SUBMITTAL IDENTIFICATION SHEET

WEBSTER UNIVERSITY ISB
PROJECT NAME

RE: Stainless Steel Courtyard Stair Rails Shop Drawings

1 SOUTH COURTYARD STAIR - ELEVAVATION VIEW

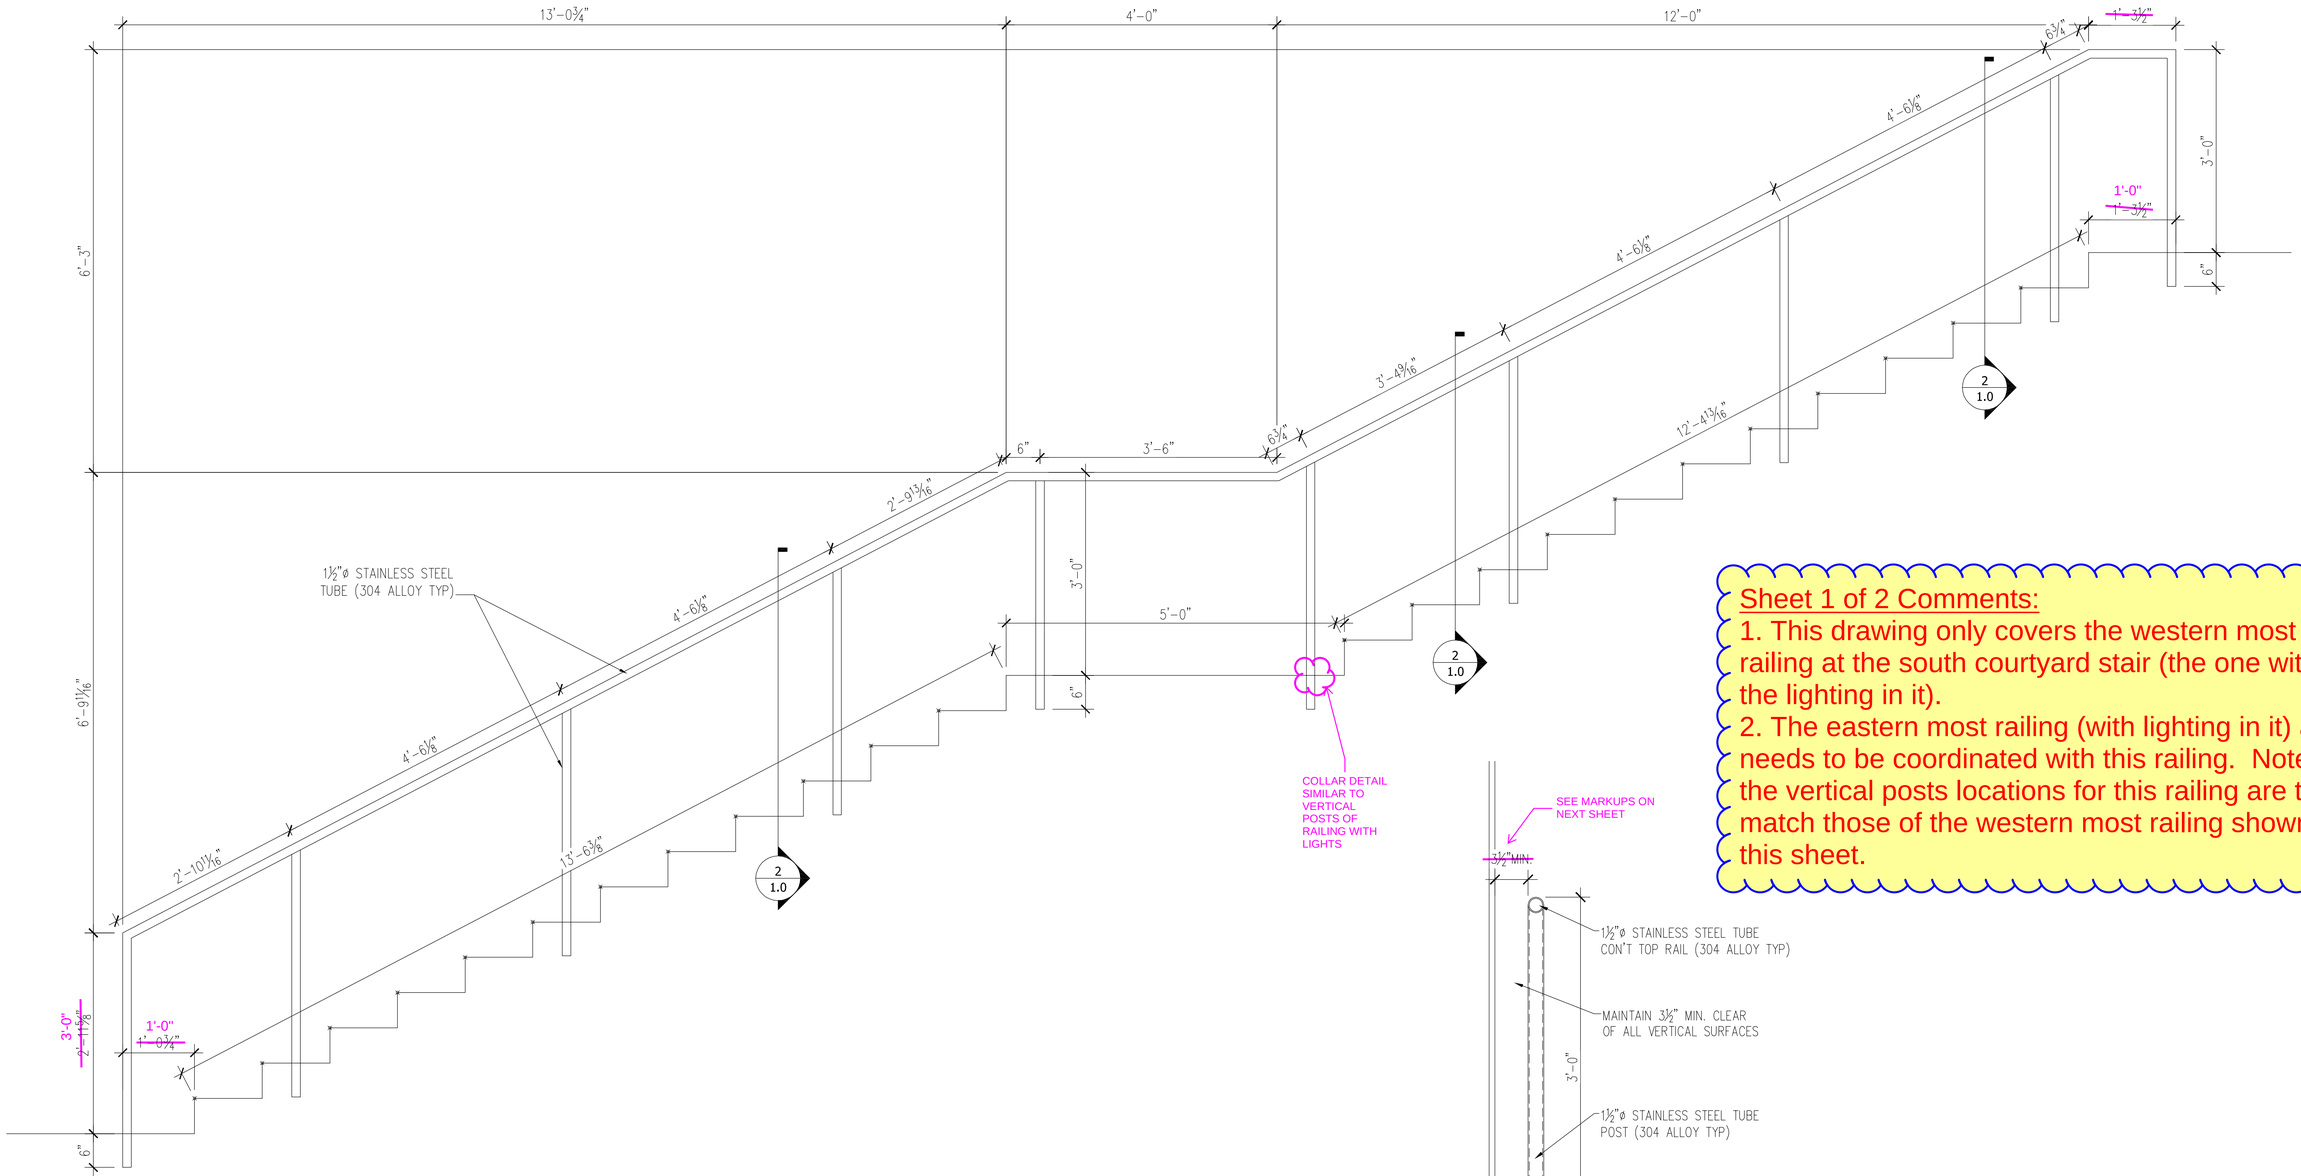
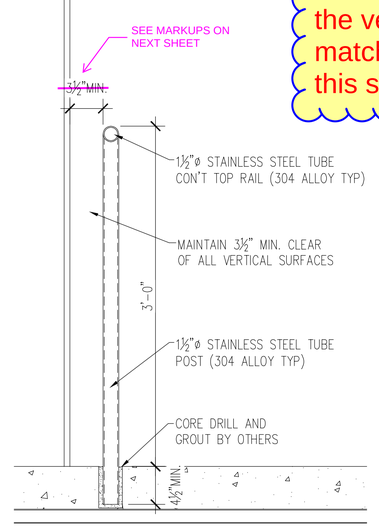
COLLAR DETAIL SIMILAR TO VERTICAL POSTS OF RAILING WITH LIGHTS

SEE MARKUPS ON NEXT SHEET

1. This drawing only covers the western most railing at the south courtyard stair (the one without the lighting in it).
2. The eastern most railing (with lighting in it) also needs to be coordinated with this railing. Note that the vertical posts locations for this railing are to match those of the western most railing shown on this sheet.

ALL VERTICAL POSTS OF HANDRAILS ON BOTH SIDES OF STAIR - WITH INTEGRATED LED LIGHTS AND WITHOUTS LIGHTS, MUST ALIGN.

1 WEST COURTYARD STAIR - ELEVAVATION VIEW
REF. A0508.A / 2

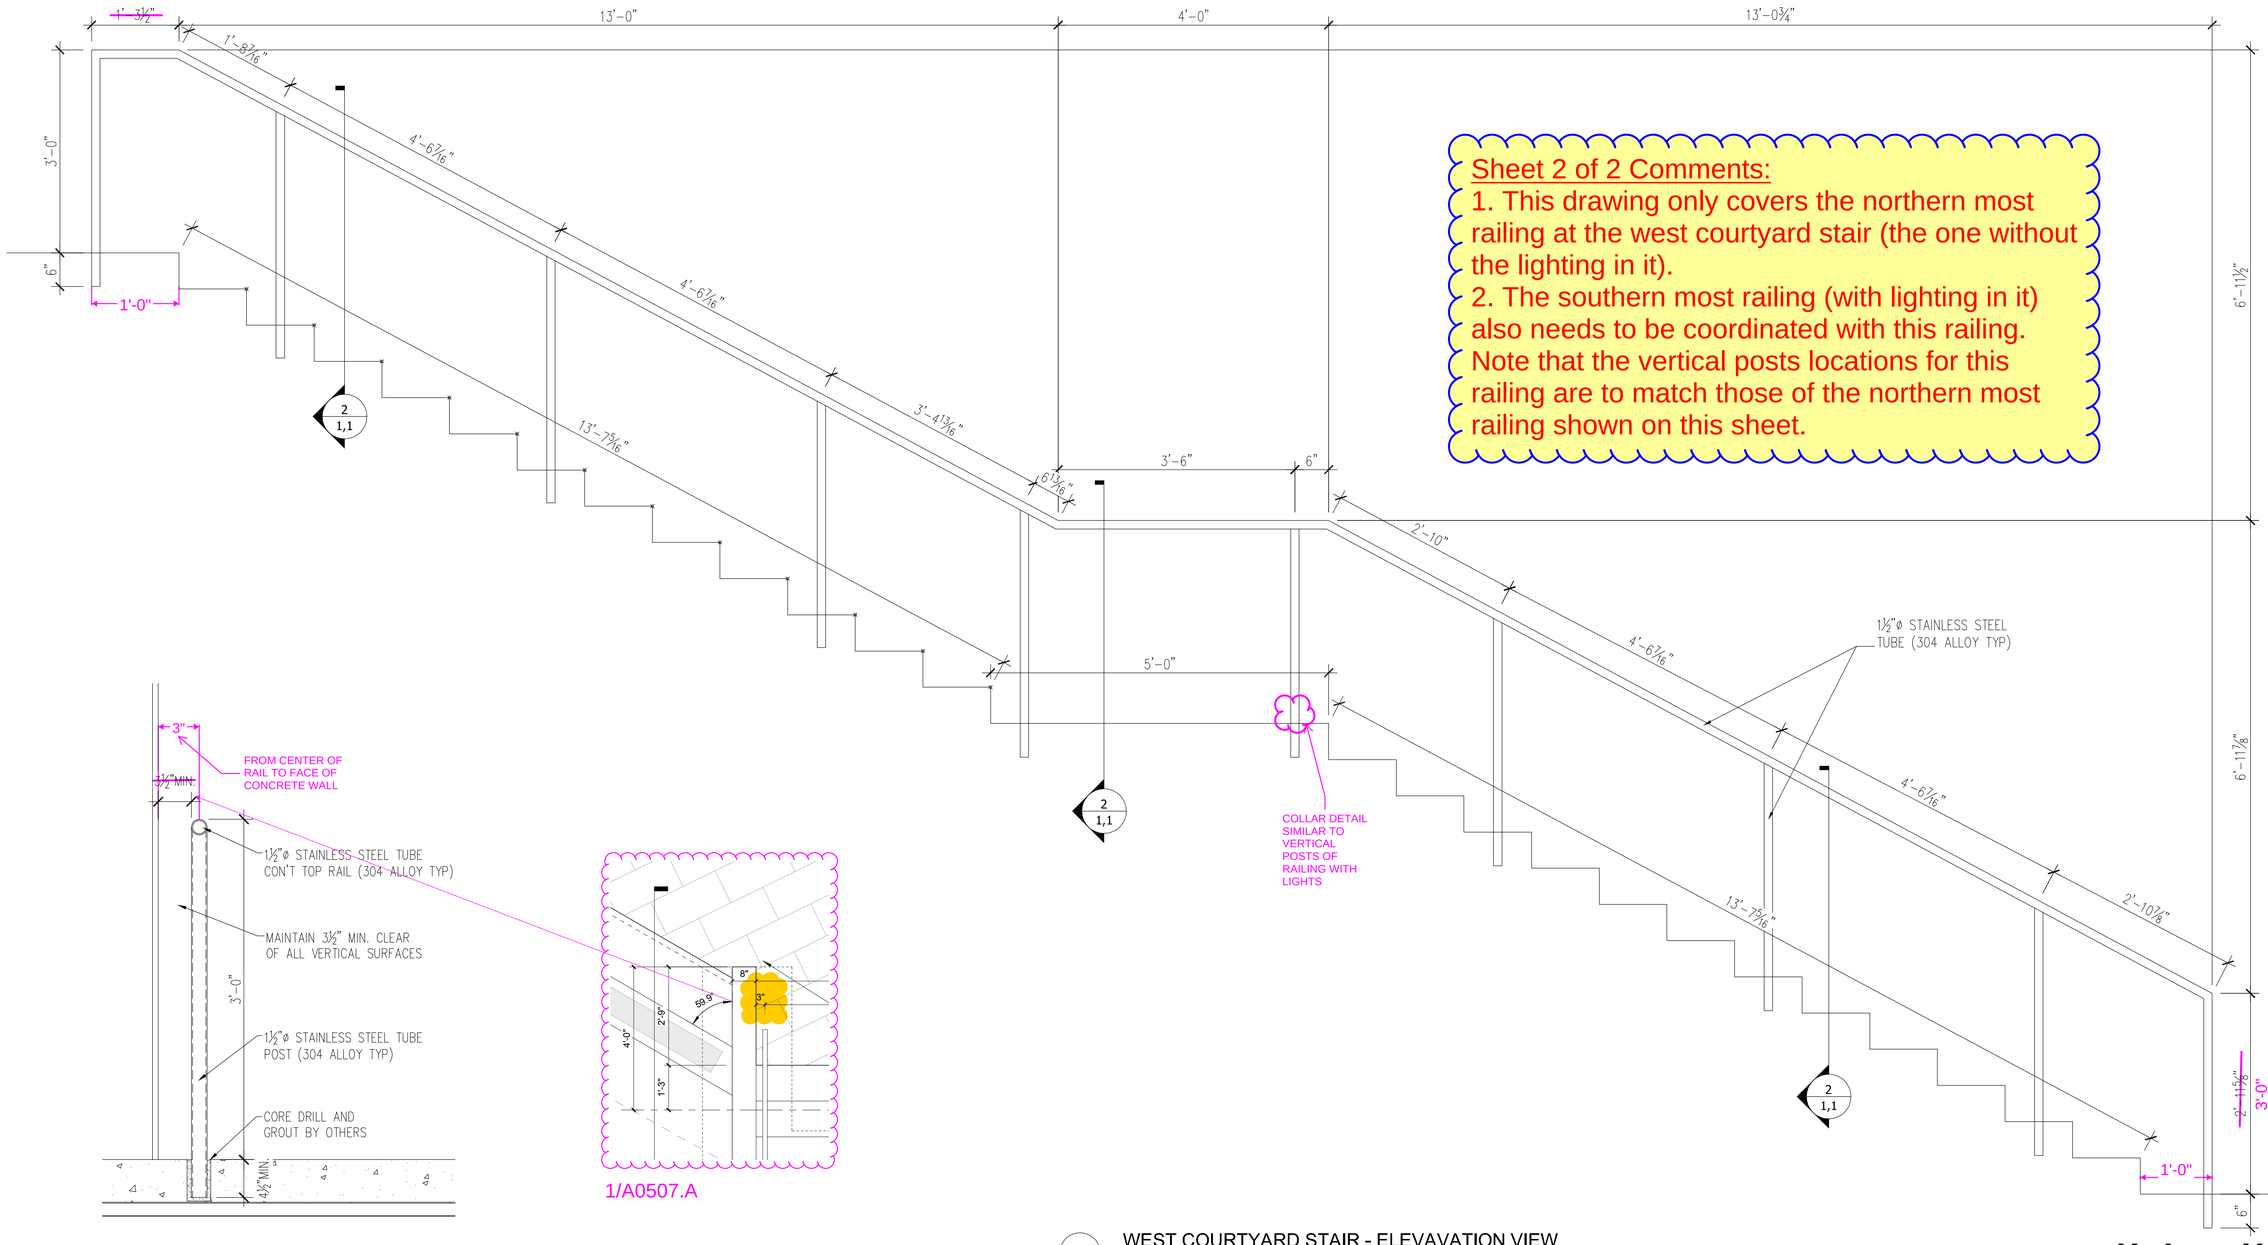
Sheet 2 of 2 Comments:
1. This drawing only covers the northern most railing at the west courtyard stair (the one without the lighting in it).
2. The southern most railing (with lighting in it) also needs to be coordinated with this railing. Note that the vertical posts locations for this railing are to match those of the northern most railing shown on this sheet.

ALL VERTICAL POSTS OF HANDRAILS ON BOTH SIDES OF STAIR - WITH INTEGRATED LED LIGHTS AND WITHOUTS LIGHTS, MUST ALIGN.

SOUTH COURTYARD STAIR - REF A0507.B

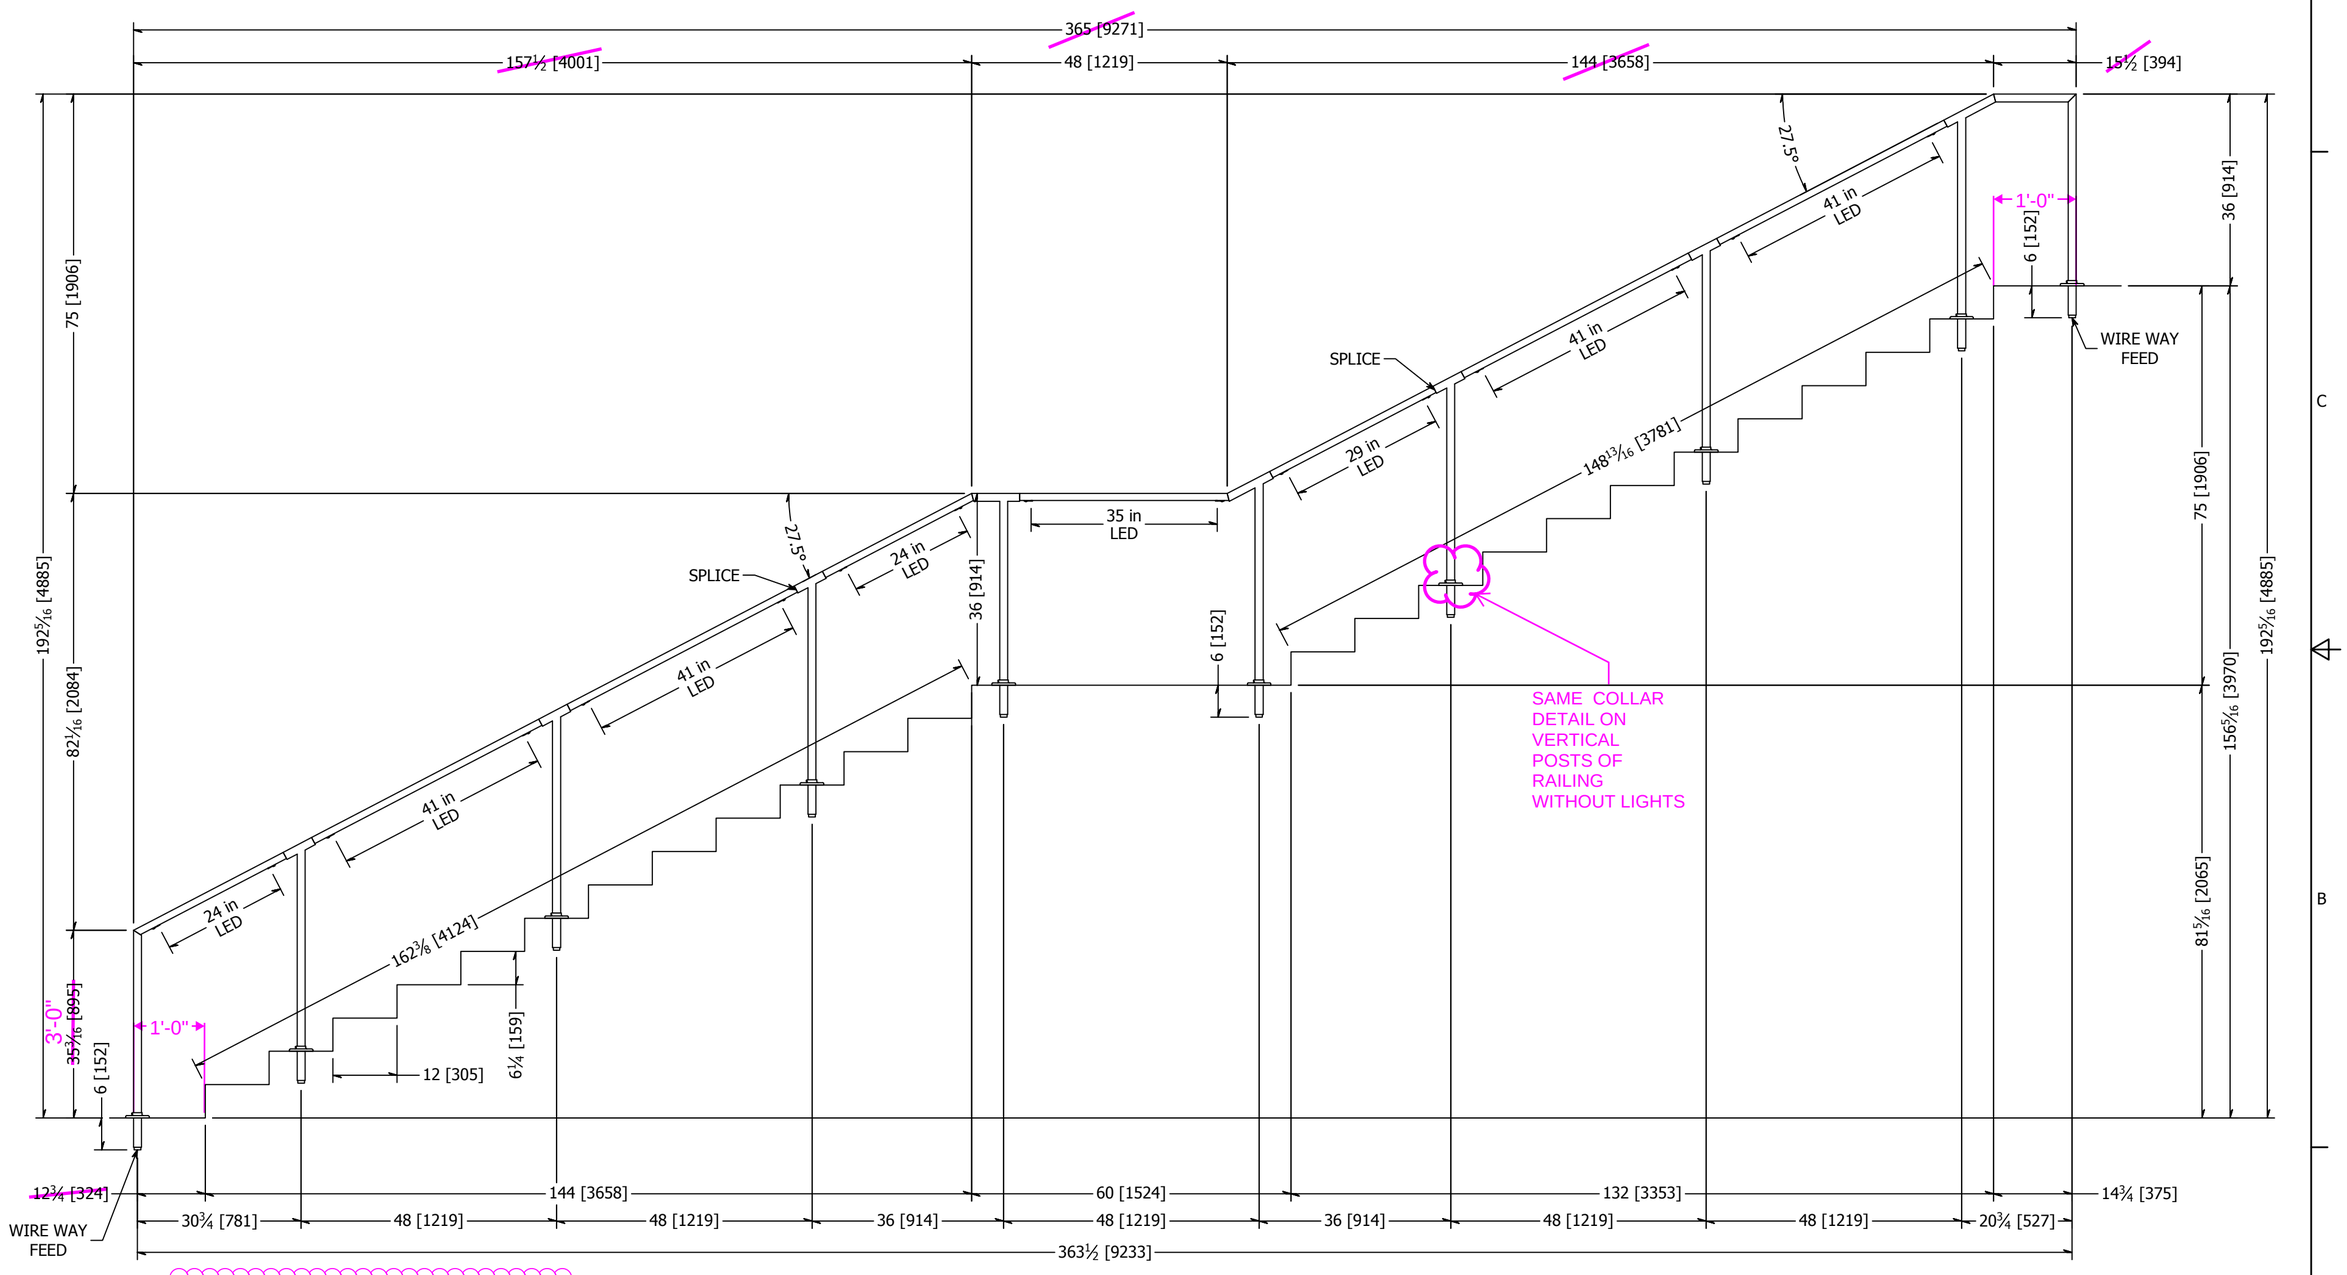
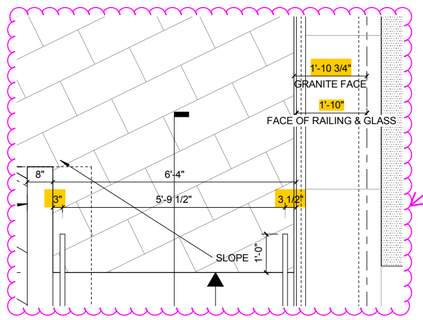
ALL VERTICAL POSTS OF HANDRAILS ON BOTH SIDES OF STAIR -
WITH INTEGRATED LED LIGHTS AND WITHOUTS LIGHTS, MUST ALIGN.
